DEVELOPMENT REVIEW BOARD  
SUPPLEMENTAL SUBMITTAL

PROJECT NO. PR-2021-005390  
Application No. SI-2021-00832 and VA-2021-00217

**Re:** Hiland Plaza Comment Responses and Supplemental Information (PR-2021-005390)

HILAND PLAZA

**BUILDING ELEVATIONS**  
 SHEET NUMBER

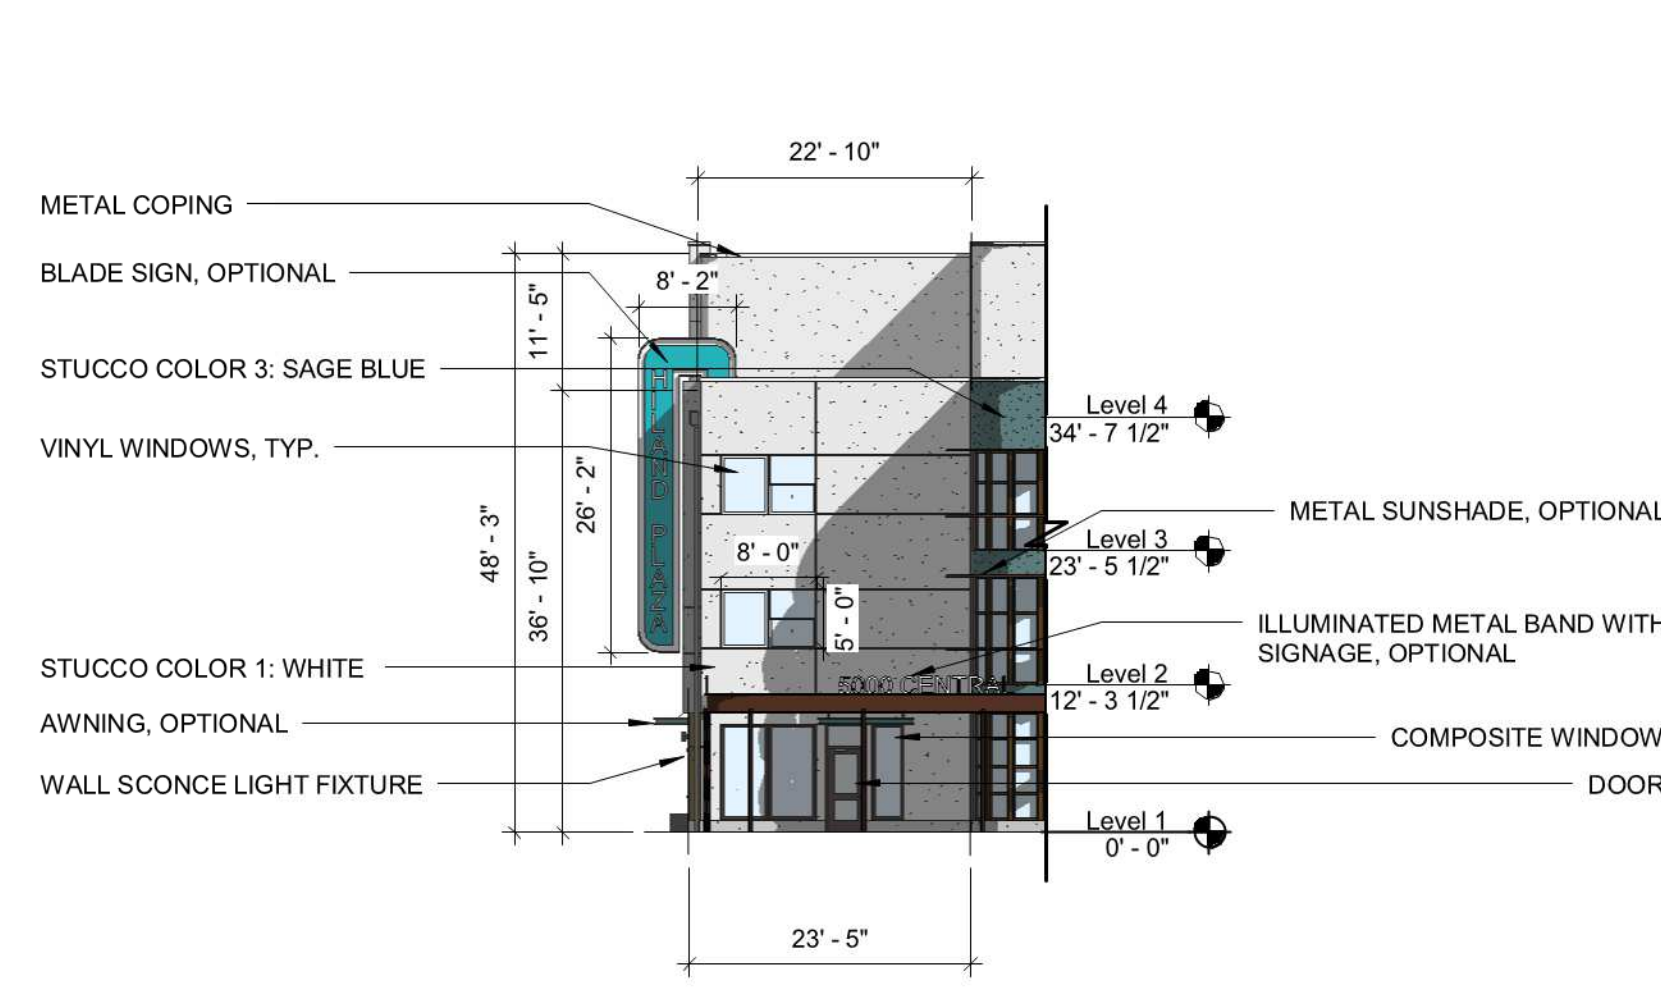
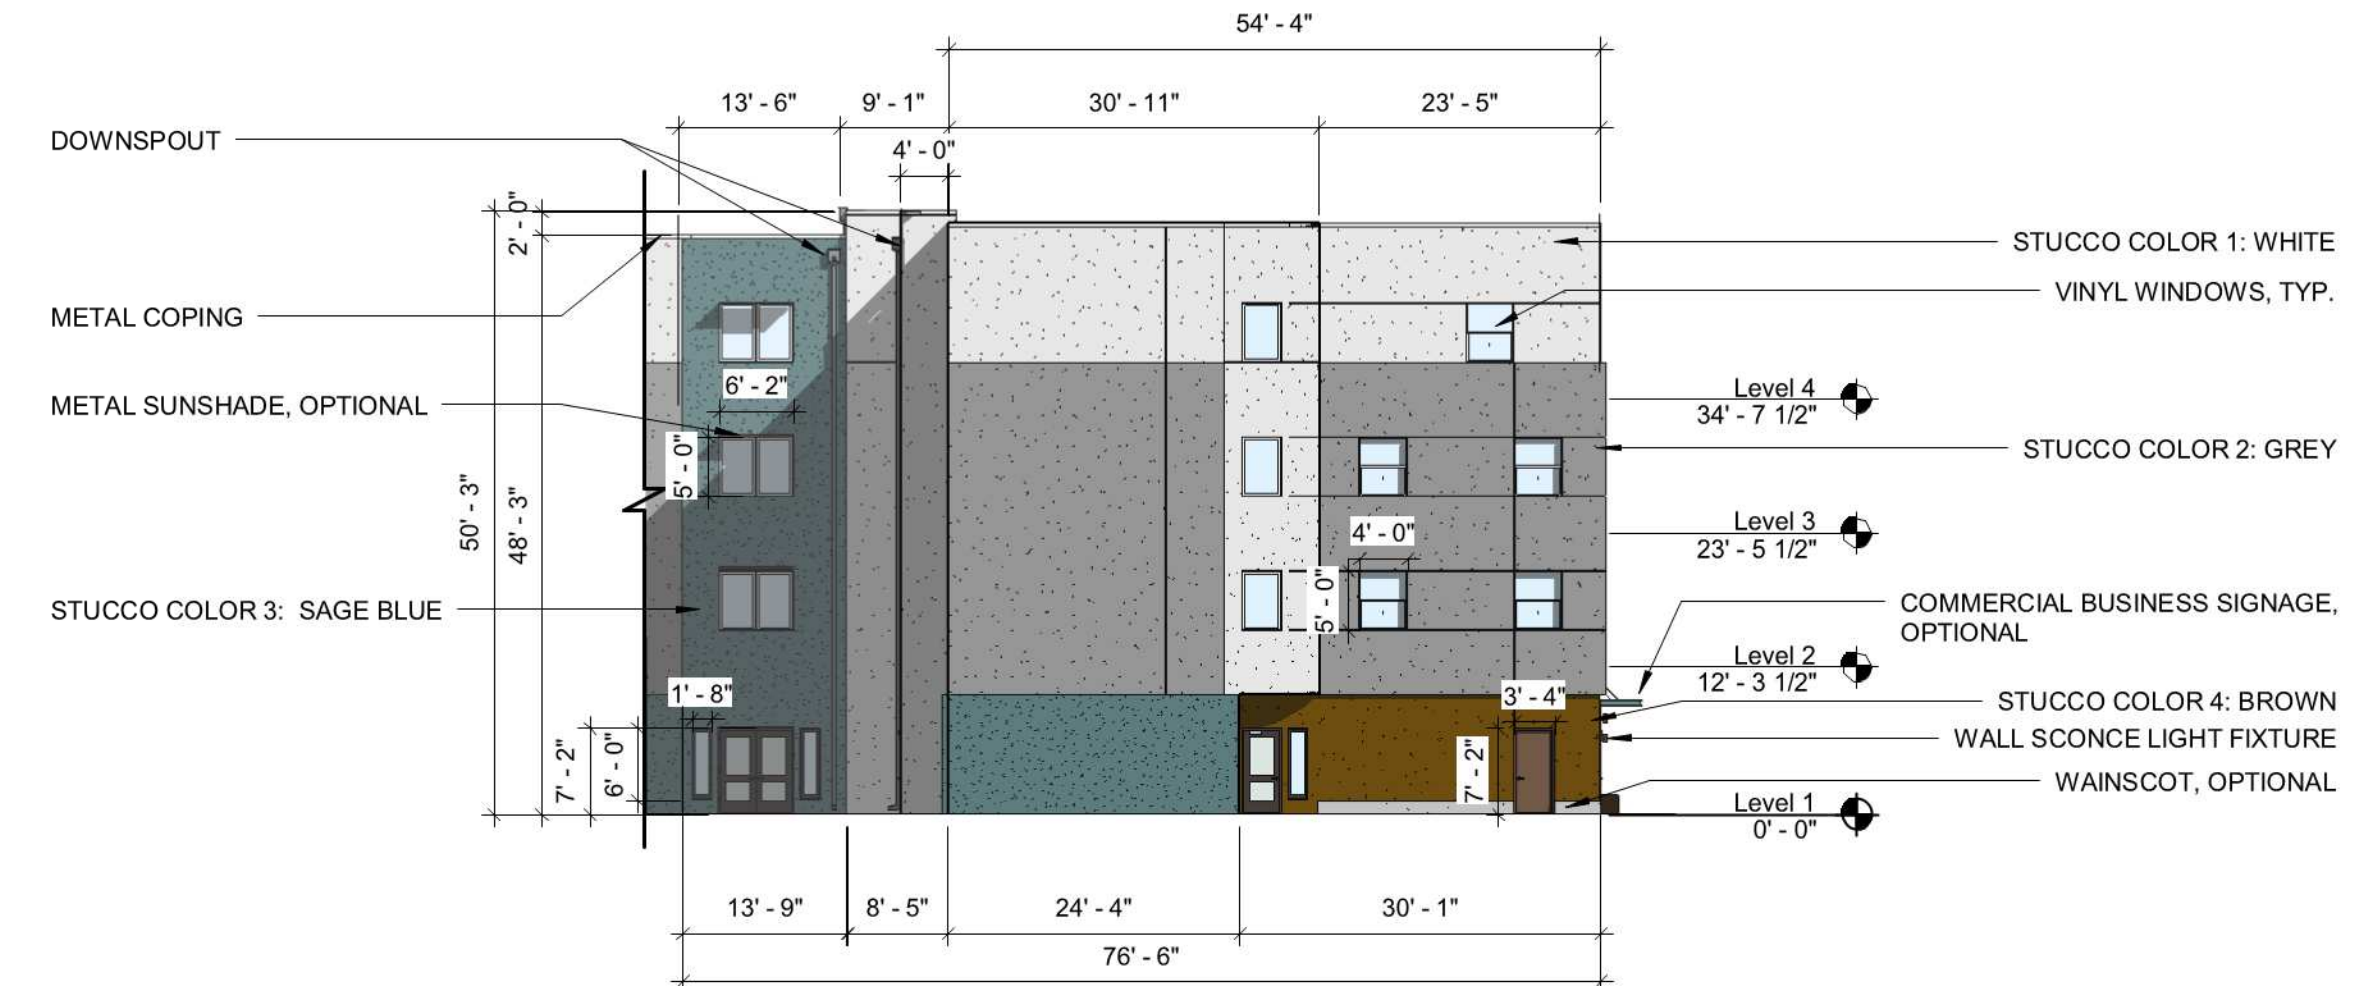
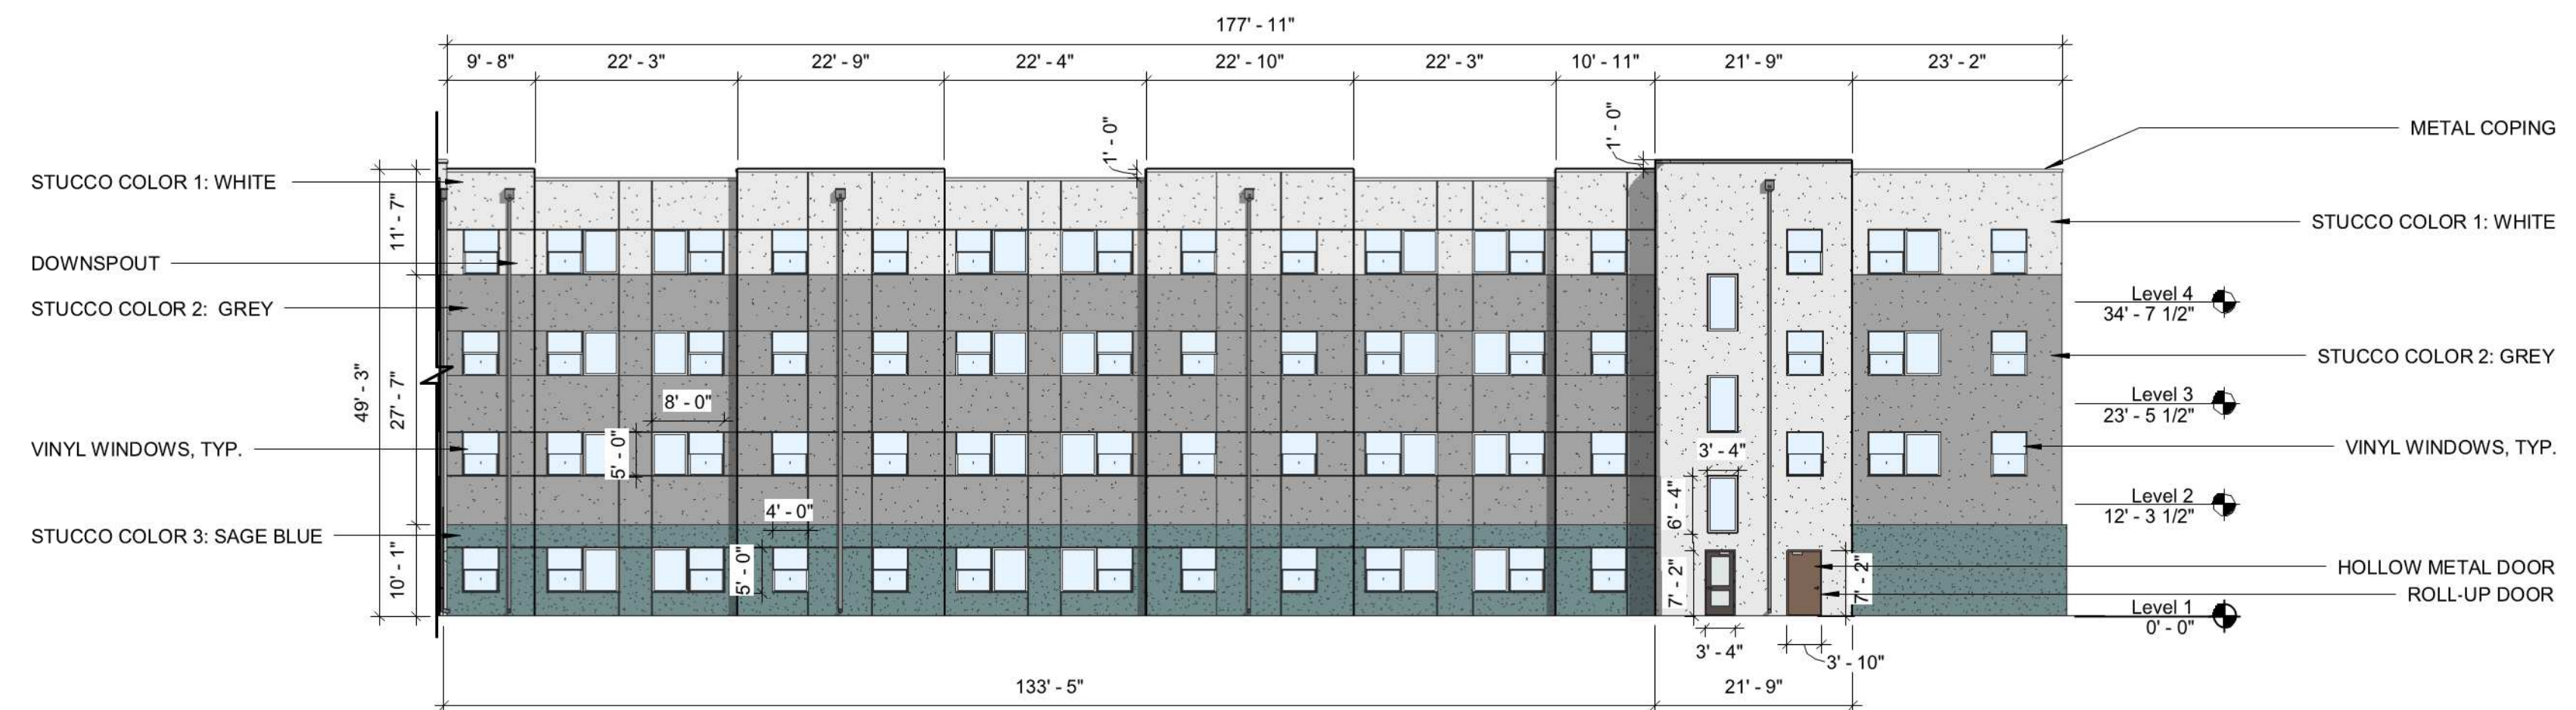
4. Provide widow detail "recessed" 5-11(D)(3) "In new multi-family residential development, windows shall be recessed not less than 2 inches and/or shall be surrounded by a window casing not less than 2 inches wide."

- a. *Understood. Planting details were updated based on Parks and Recreation comment.*
3. Please address how the façade meets these standards
4. 5-11(D)(3) Windows In new multi-family residential development, windows shall be recessed not less than 2 inches and/or shall be surrounded by a window casing not less than 2 inches wide.

- a. *Note referencing this requirement has been added to the building elevation sheet.*
5. 5-11(D)(2)(b) In UC-MS-PT areas, each floor of every façade that faces a public street shall contain a minimum of 20 percent of the façade in transparent windows and/or doors.

- a. *A note has been added to the elevations to address compliance with this standard.*

- a. *Note referencing this requirement has been added to the building elevation sheet. It should be noted that this requirement is superseded by the Nob Hill/Highland CPO requirements. We have also added notes regarding the variances to those requirements heard by the Zoning Hearing Examiner.*
